Application No.: 10/724,191
Amendment dated: 12/30/05
Reply to Office Action of 9/14/05

Amendments to the Drawings:

FIG. 7

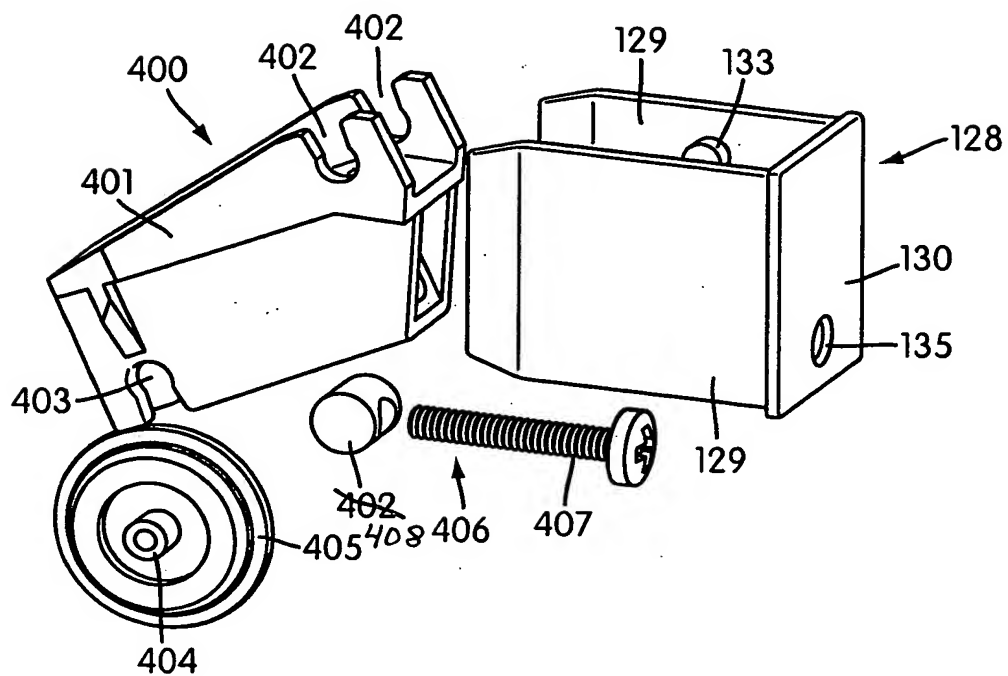
In Figure 7, the nut 402 has been changed to "408".

Figure 7 has been amended to identify the nut by the numeral 408.
